## 7. Value Management Workshop

A two day Value Management Workshop (VMW) was held on 5 and 6 December 2005. The value management workshop was used to review and assess the four route options that were placed on public display against assessment criteria to help decide on a preferred direction for further investigation to progress the planning phase of the project.

## 7.5 Refined Orange Option

Figure 7.1

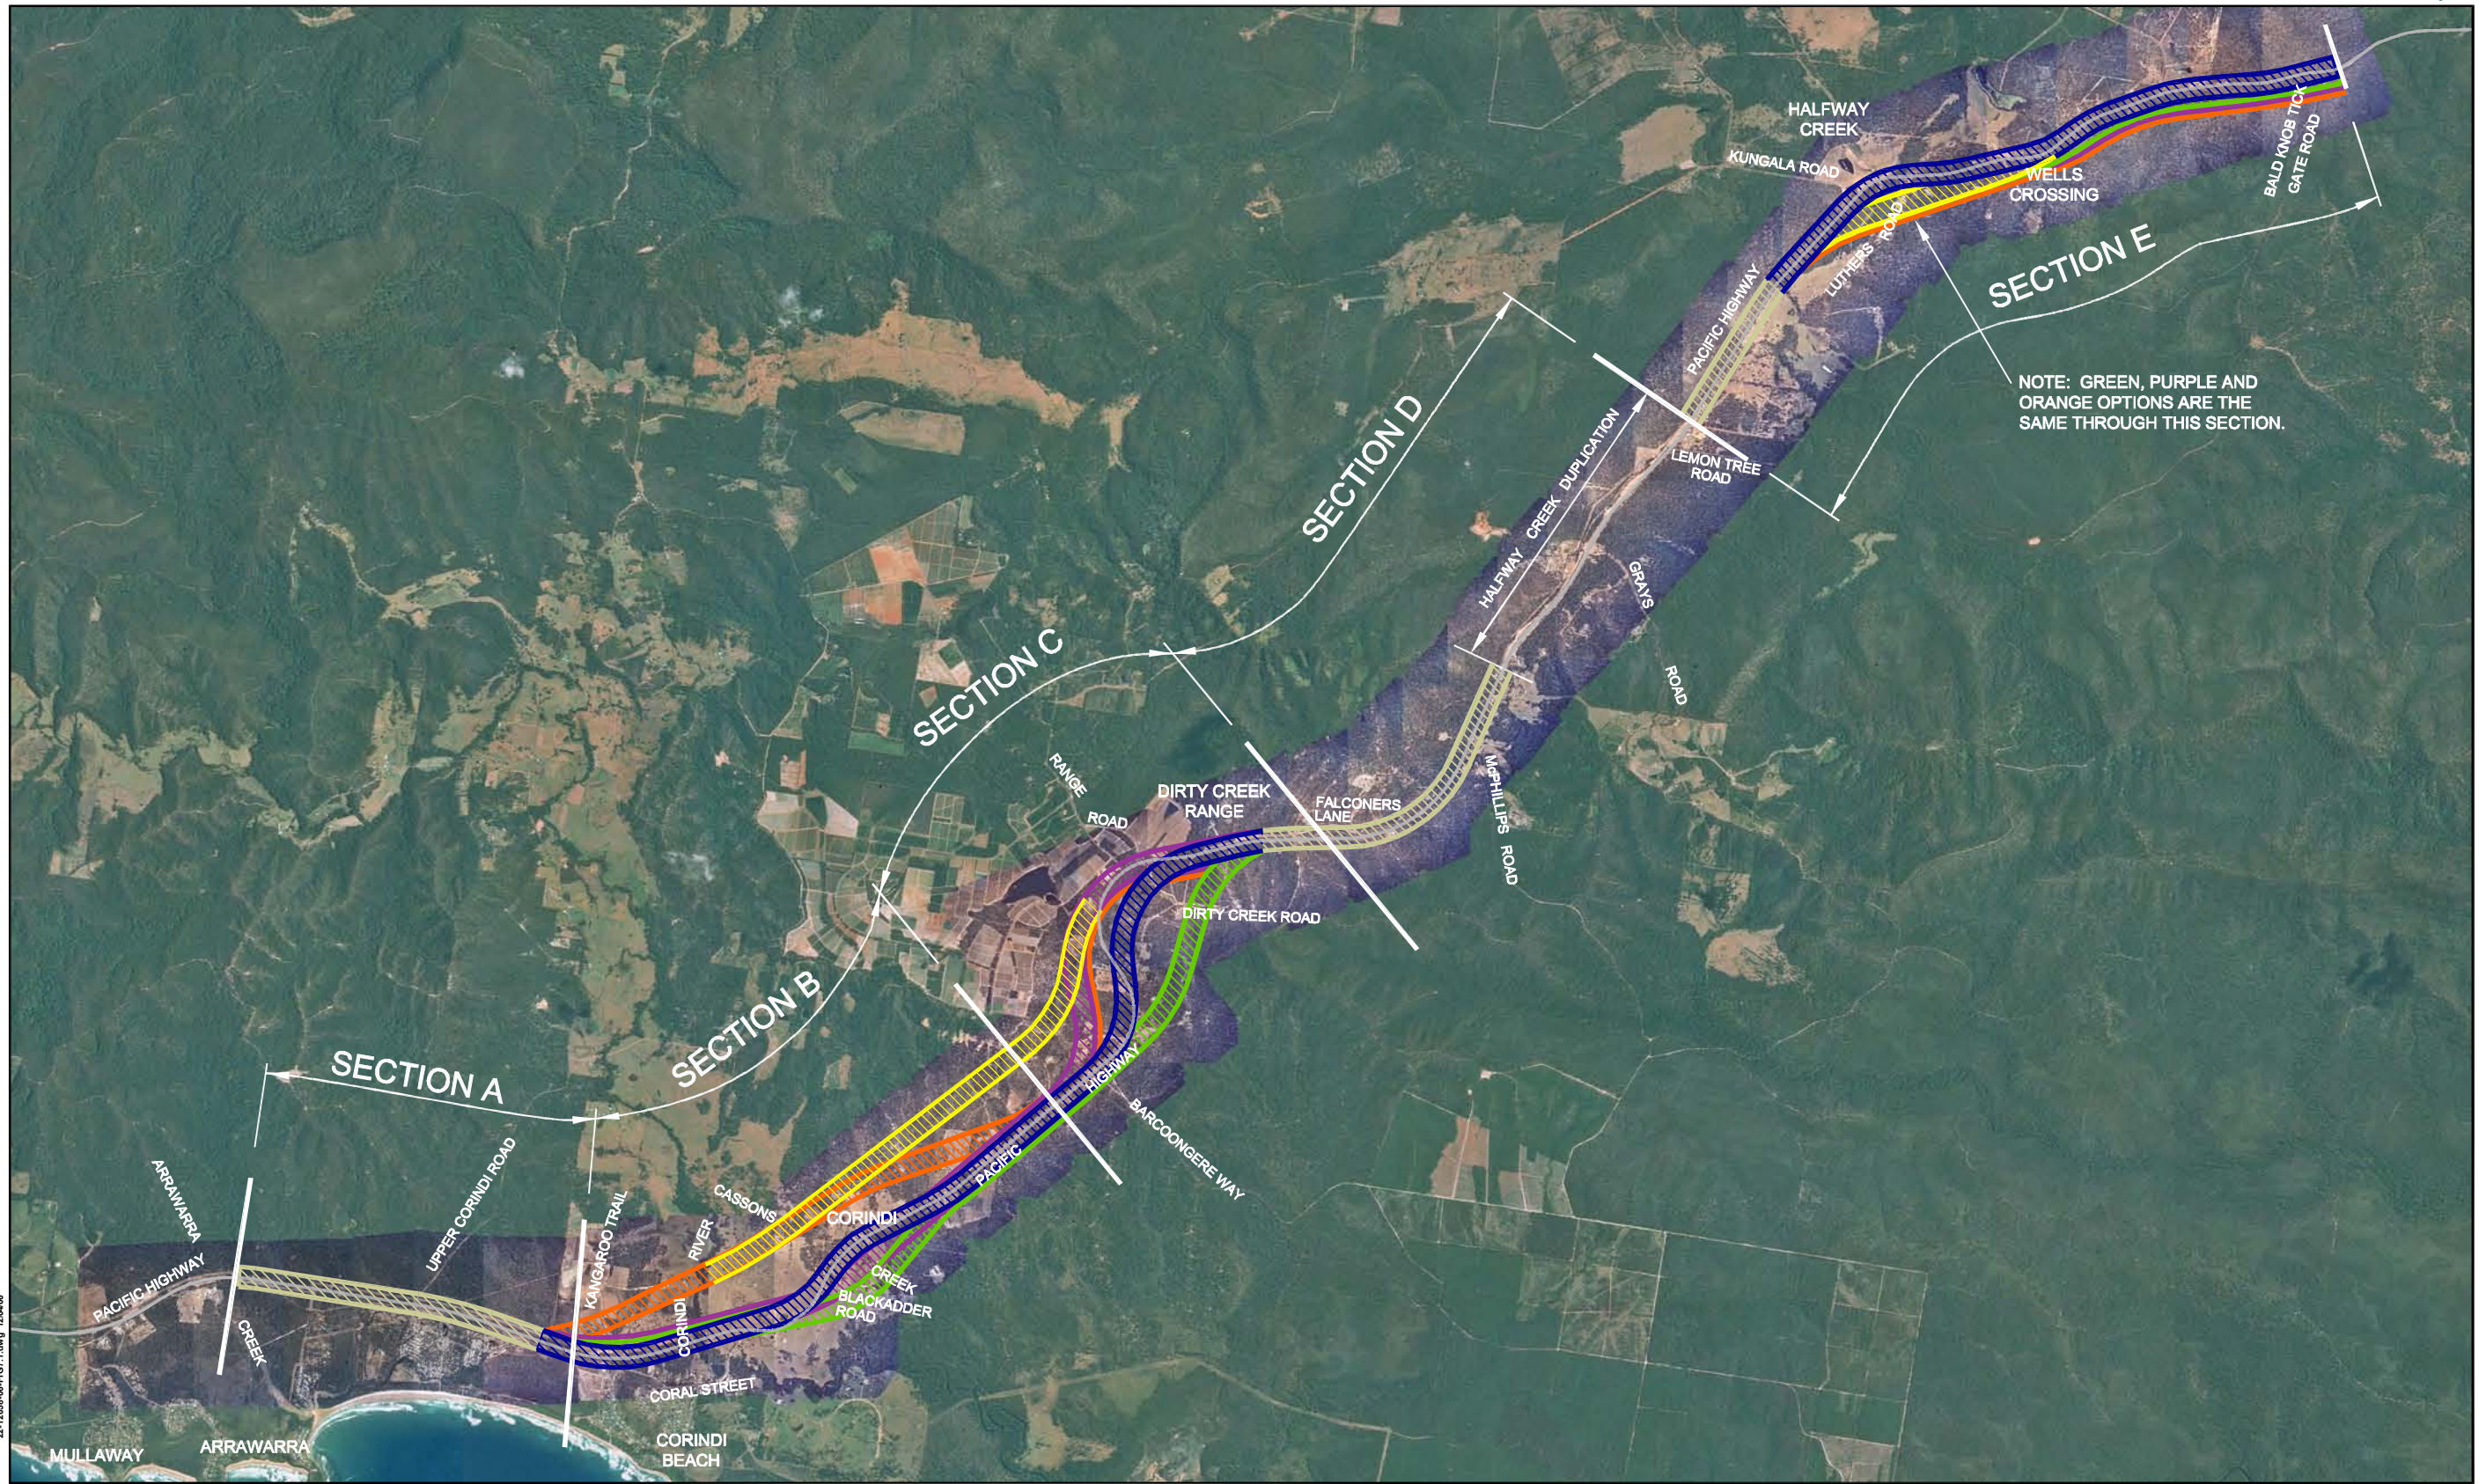
Having recommended the Orange option as the preferred option to move the project forward in Sections B, C and E, workshop participants were asked to identify possible improvements to the Orange option. One suggestion made to improve the Orange option in Sections B and C was to continue the alignment of the Orange option in a straight line from Corindi River towards Range Road instead of connecting the Orange option to the existing highway near Hawthorn Close as shown in Figure 7.1. Another suggestion to reduce the amount of vegetation to be cleared in Section E was to move the Orange corridor option further to the west (i.e. closer to the existing highway) in the vicinity of Kungala Road and Luthers Road.

Workshop participants requested and the RTA agreed that the Refined Orange option shown in Figure 7.1 be investigated further.

The outcome of these additional investigations confirmed that the following advantages and disadvantages (compared with the Orange option) would result if the **Refined Orange option** was selected in lieu of the Orange option as the preferred route:

- ▶ Length of highway reduced by approximately 500m;
- ▶ No new local access road would be required near Hawthorn Close (the Orange option would require the construction of approximately 800m of local access road to connect the existing highway near Hawthorn Close);
- ▶ Would not require an underpass (or overpass) to allow residents of Hawthorn Close to access the Highway and travel south as access to the highway for residents of Hawthorn Close would remain unaffected;
- ▶ Less disruption to traffic during construction;
- ▶ Would not impact on the disused quarry west of Barcoongere Way;
- ▶ Construction could take place clear of the existing highway – Constructability easier;
- ▶ Less impact on public utility services;
- ▶ Reduced vertical grade over Dirty Creek Range compared with the Orange option; and
- ▶ Less capital cost compared with all other options within Sections B and C.

- ▶ Increased earthworks;
- ▶ Increased cutting depth – Maximum depth of cutting would be approximately 30m;
- ▶ Greater extent of vegetation clearance; and
- ▶ Longer length of climb up Dirty Creek range (but at a reduce vertical grade) – 4.5% grade for 1km resulting in similar travel times up Dirty Creek Range compared with the Orange option, but shorter travel times compared with all other options.

- ▶ Avoids impact to Aboriginal vested lands; and
- ▶ Reduces the amount of clearing.

- ▶ Has a direct impact on the Big Garden Furniture business.

As a result of the findings from the additional engineering, ecological and heritage investigations, the RTA decided that the Refined Orange option should be considered as a refinement to the Orange option and assessed during the Project Team Route Selection Workshop along with the four route options previously developed (see Chapter 8 below).
